Re: Proposed new hotel building to be located at APN 216-030-48, La Costa Avenue, La Costa California

Subject: Addendum No. 2

- 1.- "Preliminary Geotechnical Investigation and Foundation Recommendations Proposed Commercial Structure to be located at 516 La Costa Avenue, Encinitas, California 92024" prepared by Engineering Design Group dated February 27, 2018.
- 2.- Addendum No. 1 – prepared by Engineering Design Group, dated March 4, 2019.
- 3.- Preliminary Grading Plan – 18-188 MIN/DR/CDP – 516 La Costa Avenue, APN: 216-030-48, prepared by Pasco Laret Suiter and Associates, dated 12/18/2019.
- 4.- Review of Geotechnical Report, Site Grading and Building Plans, 516 La Costa Avenue, Encinitas, California, 18-188 DR/MIN/CDP, prepared by Geopacifica – c/o James Knowlton, dated September 3, 2018.

SECTION C - C'
SCALE: 1"=10'-0"

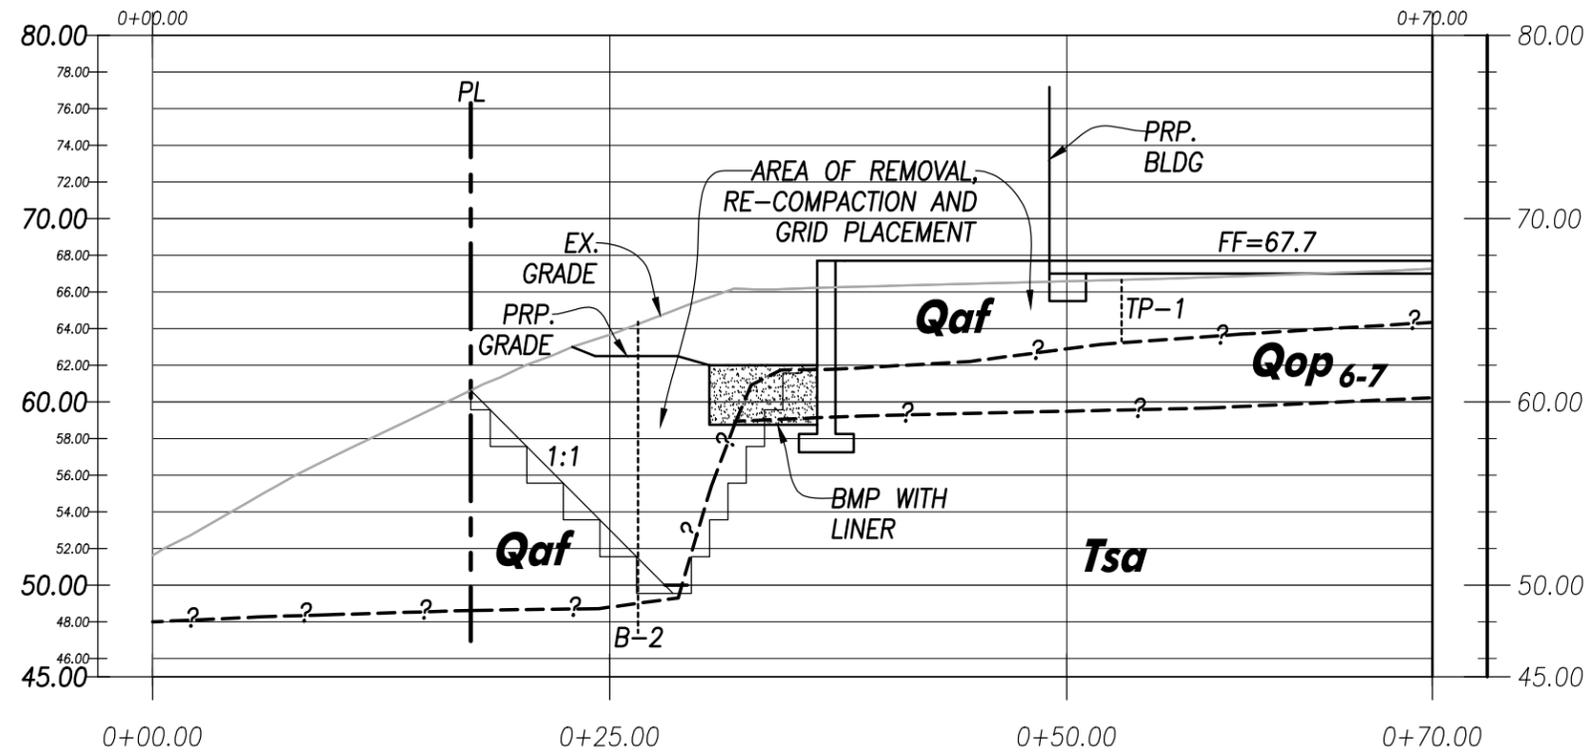
As part of the proposed site plan changes new slopes are proposed along the top of the existing rear slope. As part of our analysis of new slopes a computer-generated slope stability study was performed of the rear slope at the site. Slope stability calculations were run along two new cross-sections, C-C and D-D, utilizing Bishop’s Simplified Method. As indicated in Addendum No. 1, the minimum factor of safety against global slope stability for the existing undocumented fill slope is less than 1.5 and 1.1 for static and pseudo-static conditions, respectively. At the time of this report we understand permission to grade beyond the rear property line, from Cal-Trans is not available. As permission to grade beyond the rear property line is not available, areas of deep undocumented fills are anticipated; we recommend removals and re-grading of existing undocumented fills along the rear portion of the property, as more specifically outlined in the *EARTHWORK* section below.

Based on our additional slope analysis, and the grading recommendations outlined in this addendum, the new re-graded fill slope along Section C-C and the adjacent areas within the subject property, have a global minimum factor of safety against global slope stability of 1.5 for static conditions and less than 1.1 for pseudo-static conditions. Other portions of the rear slope, where fills are less deep, such as along Section D-D, have a global minimum factor of safety against global slope stability **greater** than 1.5 for static conditions and **greater** than 1.1 for pseudo-static conditions.

In areas of existing undocumented fill slopes and new slopes, a temporary backcut should be made from the property line, downward into the property at an approximate 1:1 slope gradient. The temporary back cut should extend through undocumented fills into competent sandstone material a

The placement of new fill should include the placement of geotextile fabric, Tencate Mirafi® Miragrid® 3XT or equivalent, starting at 2 feet above the keyway and thereafter every 2 feet vertically. Grids should extend 16 to 20 feet into the property from the property line. (Lengths may vary due to the benching and distance to property line at portions of the new fill slope)
